02 - 2010
3601B
1/2" ROUTER

SERVICE CHANGES

1. Changes on Armature Shaft and Insulation washer

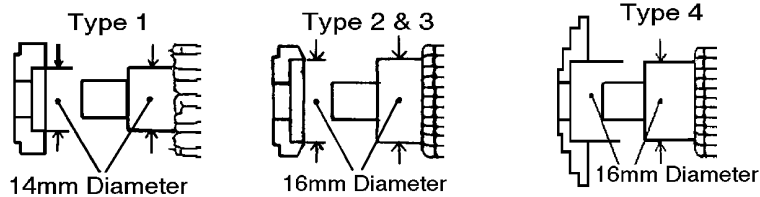
Item No.	Description	Type 1	Type 2	Type 3	Type 4
12	Insulation Washer	681607-7 (N/L/A)	681623-9 (Black)	681624-7 (White)	681635-2 (White)
14	Armature	513302-0 (or 613302-1)			
		14mm shaft	16mm shaft		
	Serial No.	~ 79904E	79905E ~		Sept 1993 ~

Above parts are completely interchangeable as a set.

2. Changes on Motor Housing, Motor Bracket and Router Base

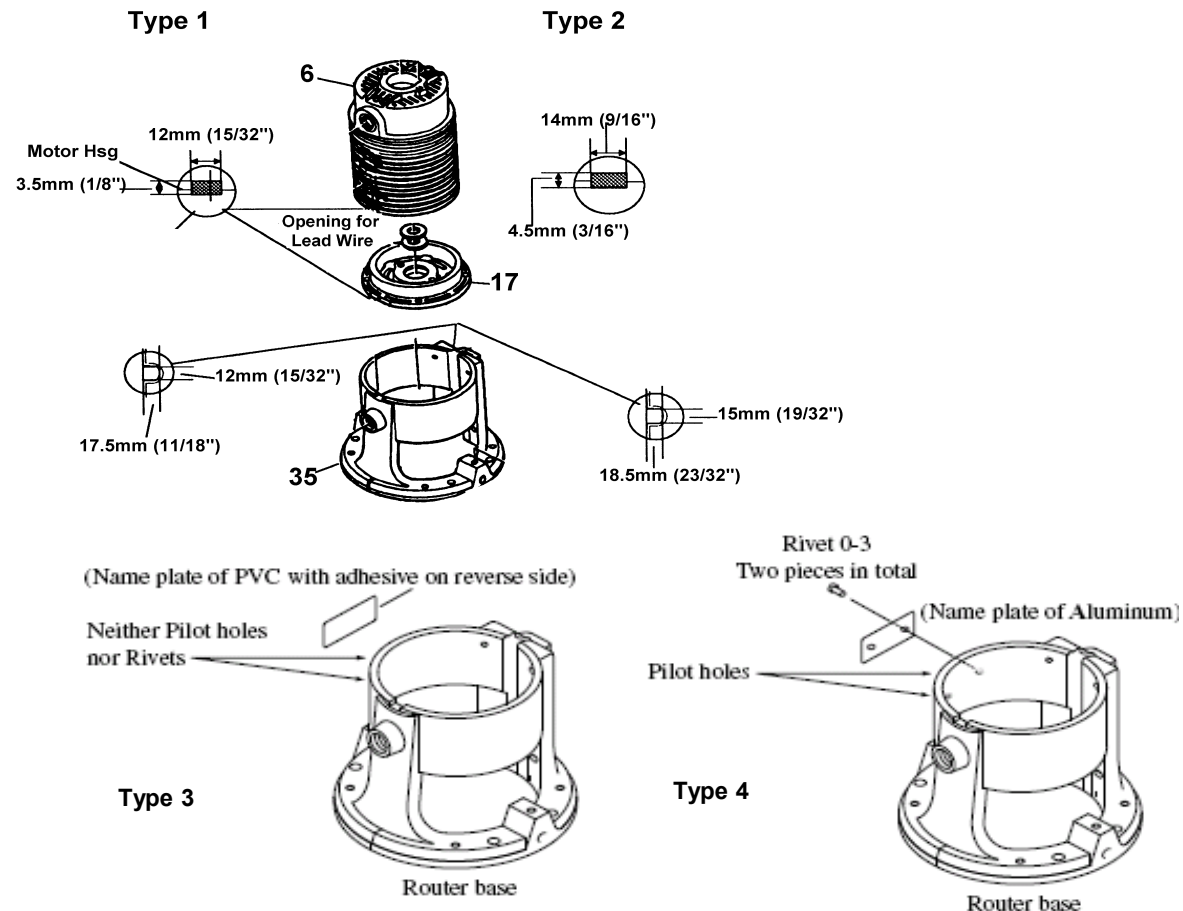
Item No.	Description	Type 1	Type 2	Type 3	Type 4	Type 5
6	Motor Housing	156399-2	159246-6			
17	Motor Bracket	312036-0 (N/L/A)	316296-6			
35	Router Base	312034-4 (N/L/A)	316316-6	316297-4	316316-6	316297-4
902	Rivet 0-3	-----	953101-2			---
	Serial No.	~ 242415E	242416E ~

Above parts are completely interchangeable as a set.
